PIVOT | Mixed-Use

BOARD COMMENT SUMMARY

DESIGN GUIDELINES | Response

DESIGN RESPONSE | Autorow Character

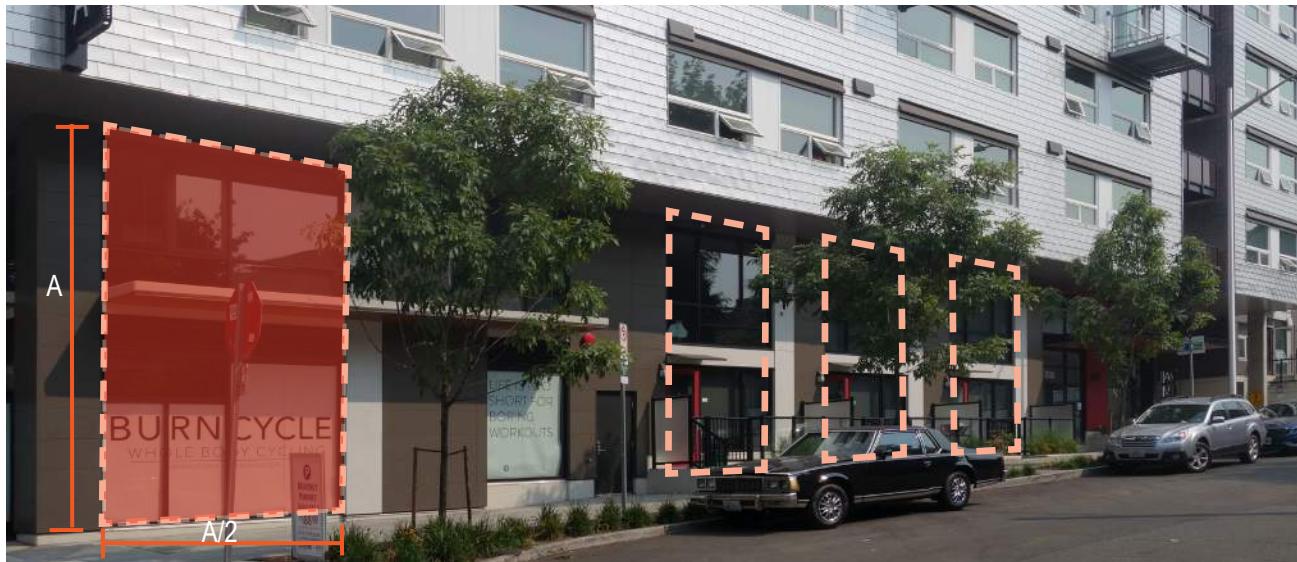
BOARD COMMENT: 1.) Create a stronger corner and articulate the building to better reflect the auto-row character of simple massing, large windows, and articulated ground floor commercial (rhythm).

BOARD COMMENT 1.) Create a stronger corner and articulate the building to better reflect the auto-row character of simple massing, large windows, and articulated ground floor commercial (rhythm).

BOARD COMMENT 5.) Utilize materials listed within the pike/pine neighborhood guidelines.

CURRENT VIEW
(ENTRY ON PINE)

SIMILAR VIEW FROM THE EDG MEETING
(ENTRY ON PINE)

EDG DESIGN VIEW
(FROM PINE LOOKING EAST)

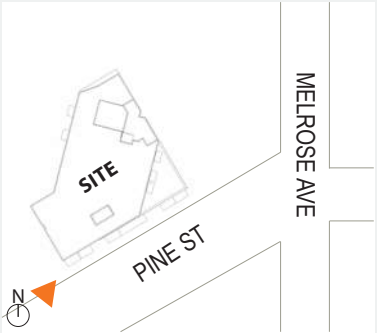
BOARD COMMENT 2.) Modify the Design to create a more cohesive design between the base and upper stories

- FORMER DESIGN WAS STRONGLY BIFURCATED BETWEEN BASE AND TOP
- BASE WAS HORIZONTALLY ORIENTED
- FORMERLY HORIZONTAL GLAZING HAS BEEN VERTICALLY ORIENTED TO INTEGRATE BASE AND TOP

- BASE/TOP DIVISION HAS BEEN BLURRED
- COLORS AND MATERIALS ARE SHARED THROUGHOUT
- VERTICALITY KNITS BASE AND TOP TOGETHER

EDG VIEW
(FROM PINE LOOKING WEST)

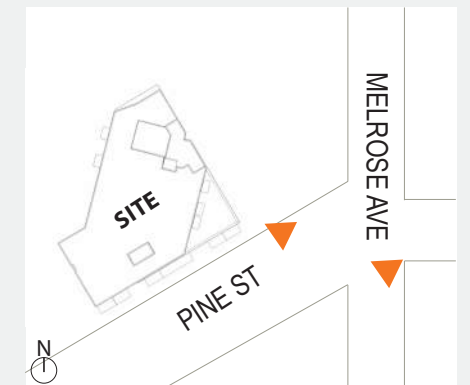
BOARD COMMENT 1.) Create a stronger corner and articulate the building to better reflect the auto-row character of simple massing, large windows, and articulated ground floor commercial (rhythm).

MASSING HAS BEEN SIMPLIFIED

ERODED CORNER HAS BEEN REMOVED.

RIBBON GLAZING EXCHANGED FOR LARGE, INDUSTRIAL WINDOWS

GROUND FLOOR HAS EXPRESSED COMMERCIAL BAYS
